1822 Bank Street

URBAN DESIGN BRIEF - R3

April 3, 2025

RESPONSE TO URBAN DESIGN COMMENTS

VIEW FROM ABOVE NORTHWEST SHOWING 45 DEGREE ANGULAR PLANE

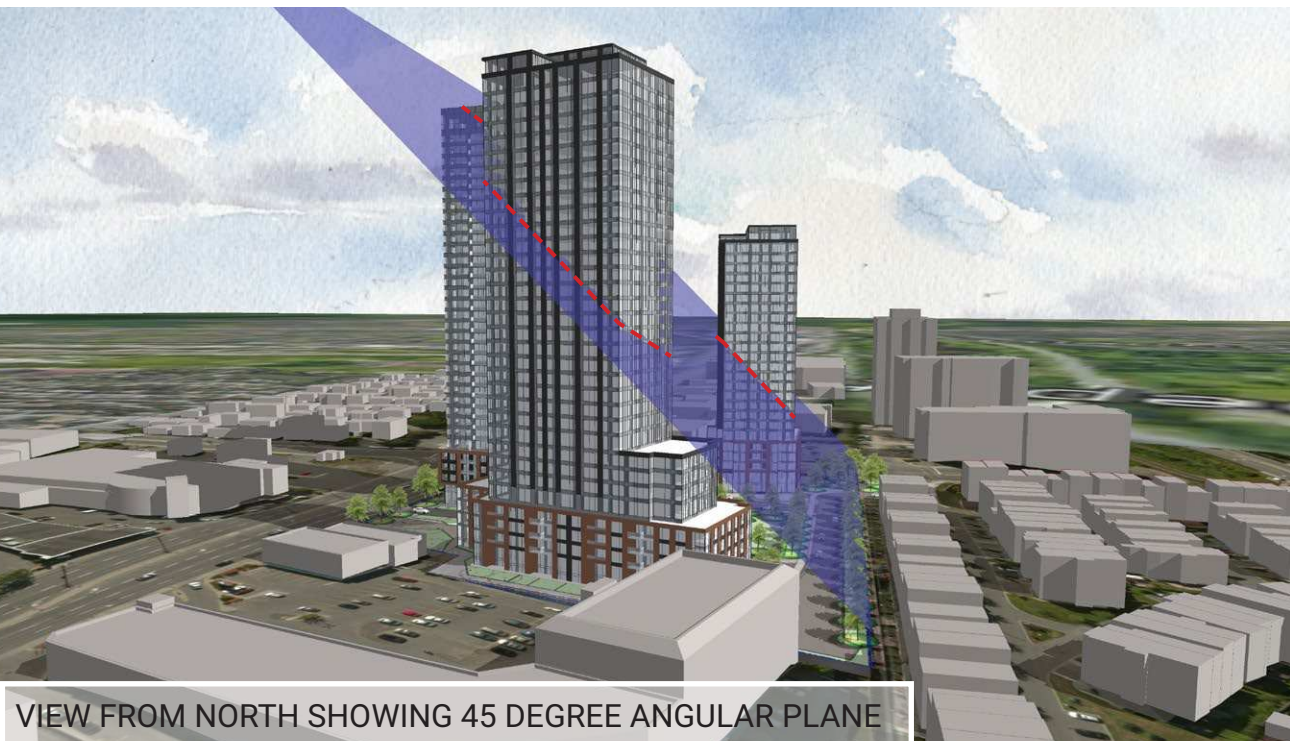
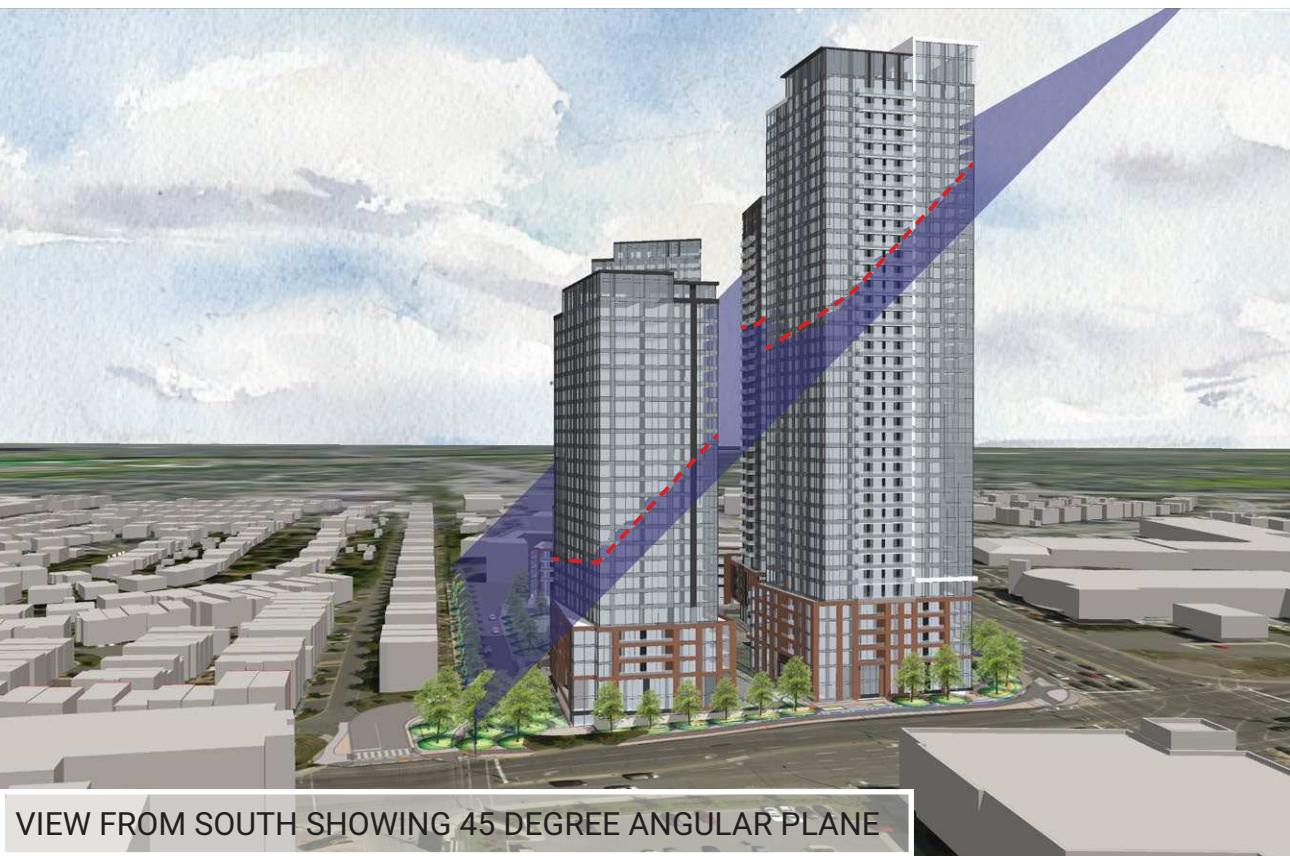
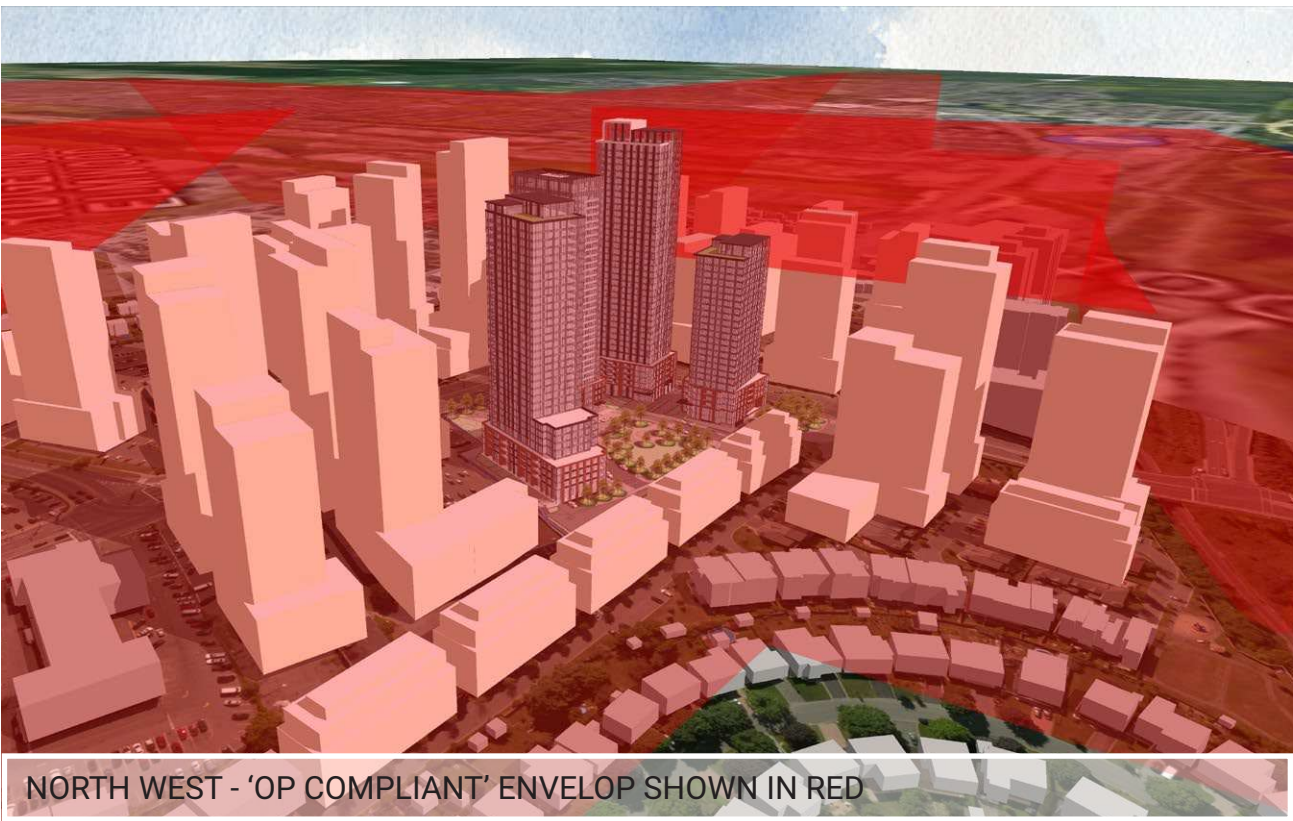
17. Towers 1 and 4 protrude significantly above the 45-degree angular planes as shown on page 20 of the submitted Design Package.
- i. Tower 1 – At the current proposed location and floorplate size, the height of the tower appears to be too tall.
 - ii. Tower 4 – The height should be reduced. It is interesting to note that if Tower 4 is a 16-storey building, permitted by the Secondary Plan, it will not protrude above the angular plane.

28. Slide 20 of the Design Package demonstrates the buildings projecting above the angular plane. While the angular plane is not meant to be a rigid determination of heights, it does inform the general appropriateness of building heights. In this case, it seems to me that Building 4 should be reduced by several storeys. In addition to improving the building height transition, this would add more variation to the building heights.

Applicant: We acknowledge that towers 1 and 4 protude through the angular plane. However we feel that this massing response is reason given the significant adjacent open space gained by locating the park at the west side of the property closest to adjacent low-rise. The park location serves to balance the impacts of the taller building forms. Additional, building 1 is the closest of the buildings to the new transit station, and therefore an appropriate location for a taller / higher density form.
